FACPAC PO Change Order Supplemental Information Form (Ref# 61835)

Tier 1 Project: CHHS Phase 2

In accordance with PR #014 and the attached contractor pricing, contractor shall include all required labor, material and equipment necessary to increase size of door D109C to 8' wide by 10' tall.

Proposal Request

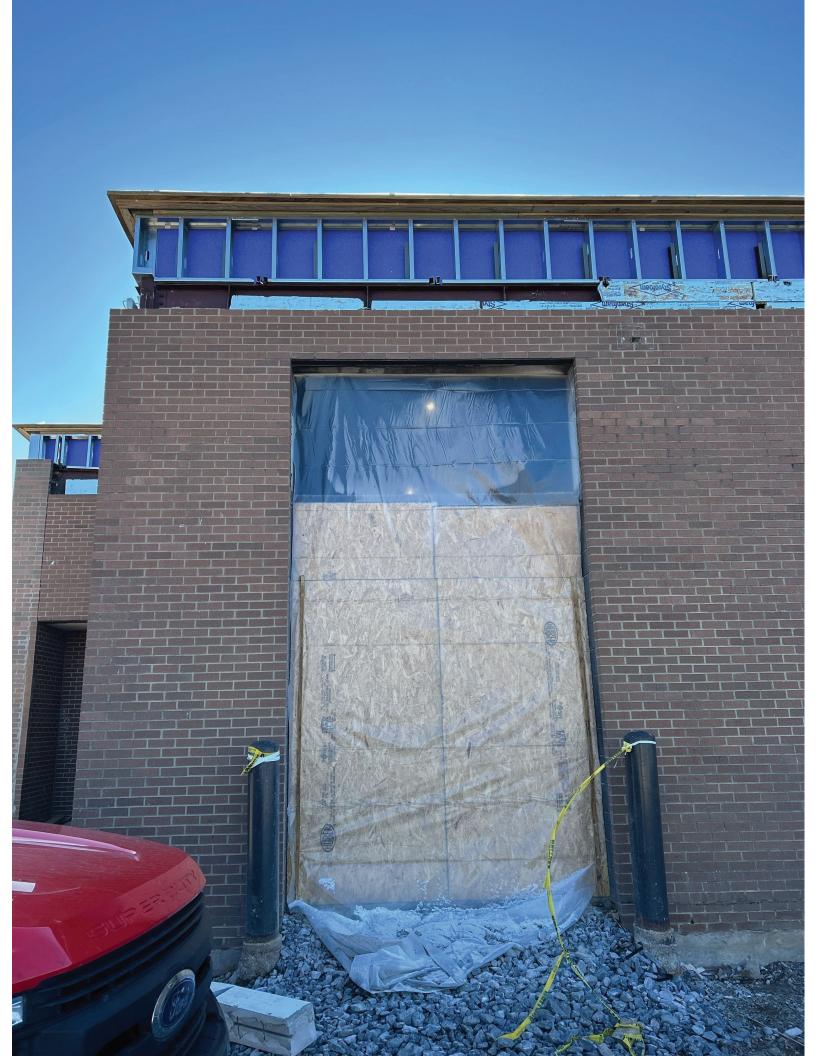
Per RFI 21, the existing opening for Door D109C shows a coiling door with metal panel over it. Revise door to 8' wide by 10' tall and remove existing metal panel and backup as required. Add lintel and brick/cmu above to infill opening above door. Provide a HSS12x4x5/16 LDV with continuous bottom plate. Bottom plate would be 5/16" thick, galvanized and the edges of the bent plate would stop ½" shy of the face of the wall and brick. Remove the 7 courses of existing brick above so that portion above door is all new brick and provide control joints on the sides, like other areas on the building.
